M-9A0 (Calpella + N11P/M Discrete Graphic)

FOXCONN		HON HAI Precision Ind. Co., Ltd.	
Title		ARD(Power)	
Size	Document Number	Rev	
Custom	M9A0 MP	1.1	
Date:	Wednesday, October 28, 2009	Sheet	5 of 73

FOXCONN		HON HAI Precision Ind. Co., Ltd.	
		CCPBG - R&D Division	
Title	PCH (PCI-E, SMBUS, CLK)		
Size	Document Number	Rev	
Custom	M9A0 MP	1.1	
Date:	Friday, October 23, 2009	Sheet	10 of 73

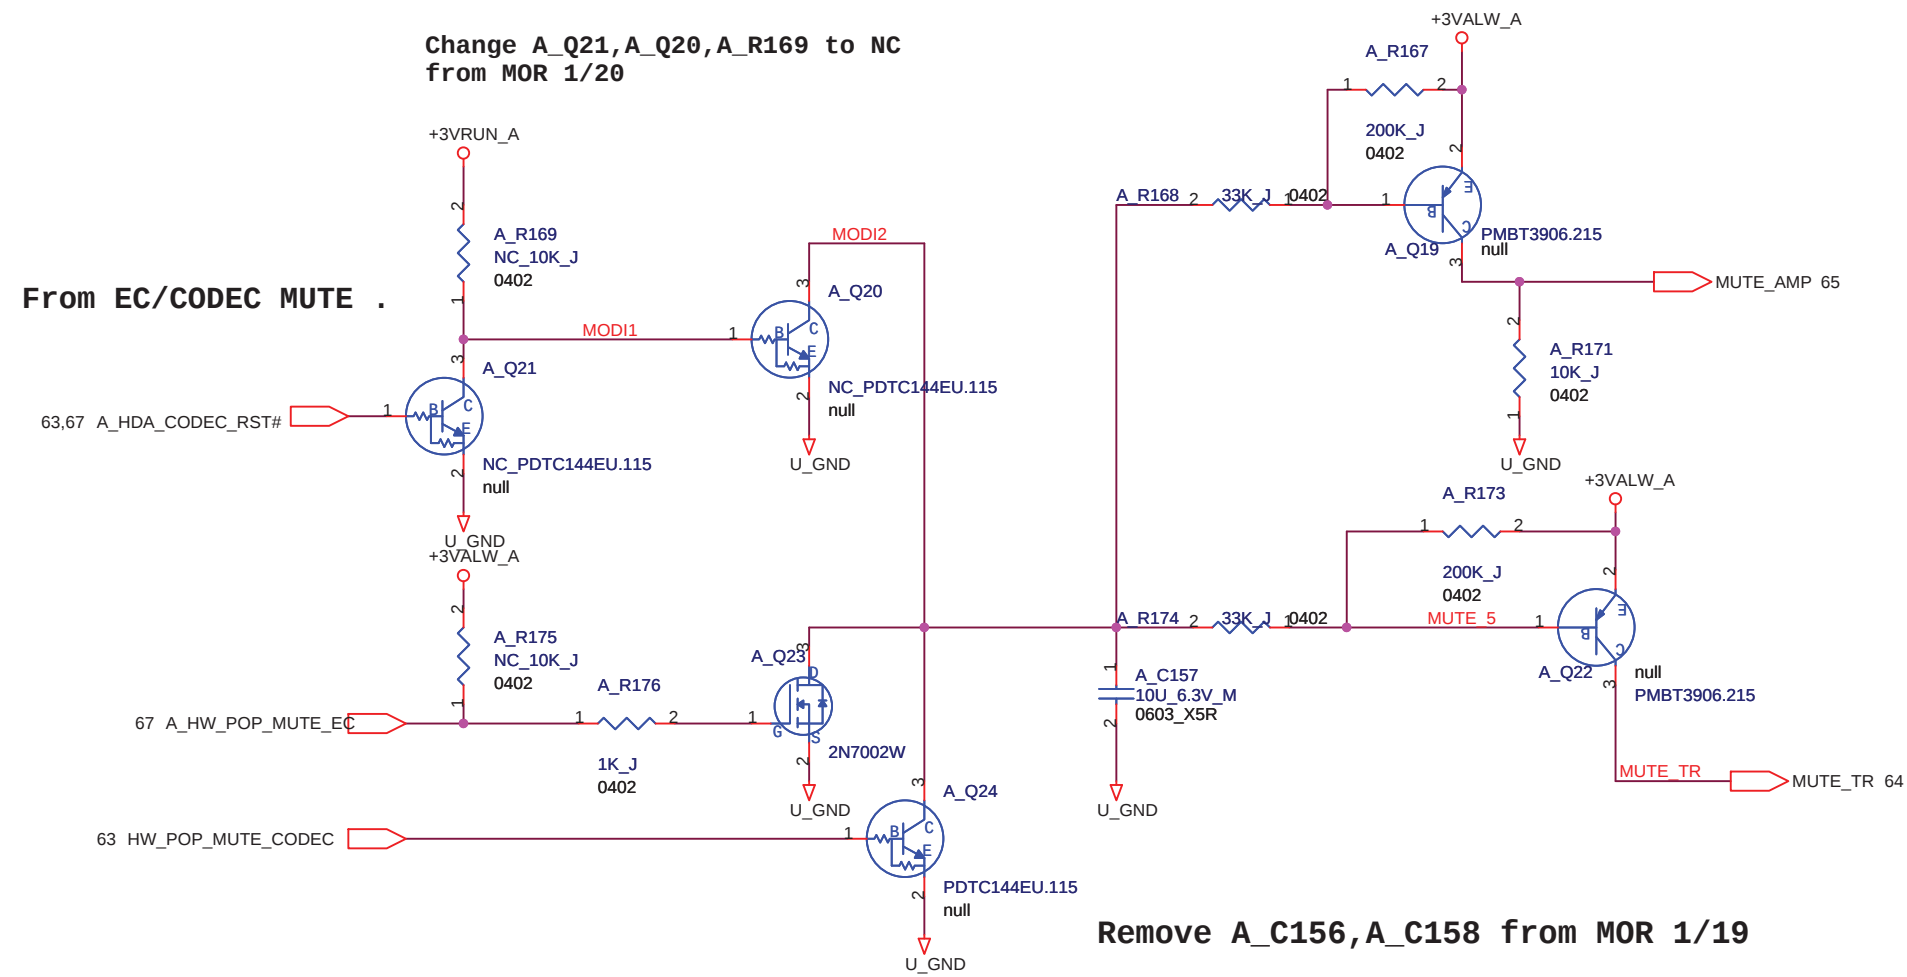
For Mor request, add the speaker cable short protection circuit
